# Work Order ID 77736

Item Name: Crosstube Turning Detail

<b>DART AEROSPACE LTD</b>		<b>Work Order:</b> 77736
<b>Description:</b> Crosstube Assembly (205/212/412 High Fwd)		<b>Part Number:</b> D212-664-141
<b>Inspection Dwg:</b> D212-664-141 <b>Rev:</b> D		<b>Page 1 of 1</b>

DRAWING NO. D212-664-141	TITLE XTUBE ASSY (205/212/412 HI FWD)	REV. D	DART AEROSPACE LTD ENGINEERING ORDER		D.E.O. NO. D212-664-141-D-1	SHEET NO. SHEET 1 OF 2	SCALE NTS
DRAWN	CHECKED	MP	MFG. APPR.	EE	APPROVED	MP	DE APPR.
DATE 11.04.07	DATE 11.04.11		DATE 11.04.12		DATE 11/04/12		DATE 11.04.12

**D212-664-141/-141B  
ASSEMBLY DETAIL**

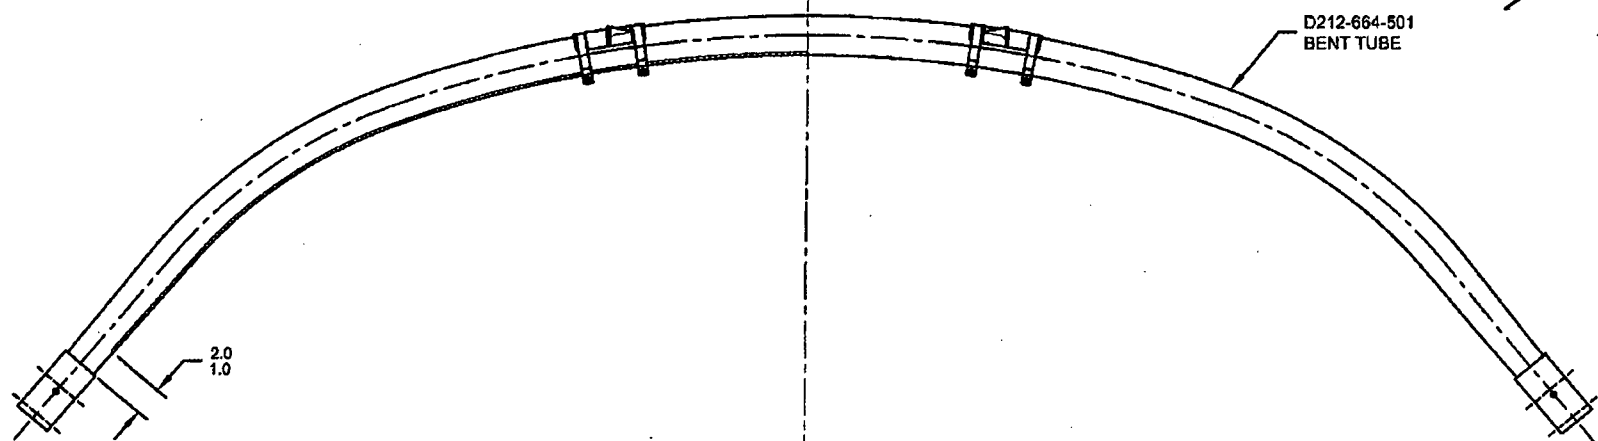
ADD AN INSPECTION WINDOW TO UNDERSIDE OF CROSSTUBE.

NOTES 2 OF SHEET 1 IS AMENDED AS FOLLOWS:

- 2) FINISH: CHEMICAL CONVERSION COAT PER DART QSI 005 4.1  
PRIME INSIDE AND OUTSIDE PER DART QSI 005 4.2  
MASK UNDERSIDE OF CROSSTUBE AS SHOWN (HATCHED AREA) AND  
PAINT OUTSIDE PER DART QSI 005 4.2  
REMOVE MASKING AND APPLY CLEAR COAT

MASK AREA PRIOR TO PAINTING,  
REMOVE MASKING AFTER PAINT  
AND APPLY CLEAR COAT
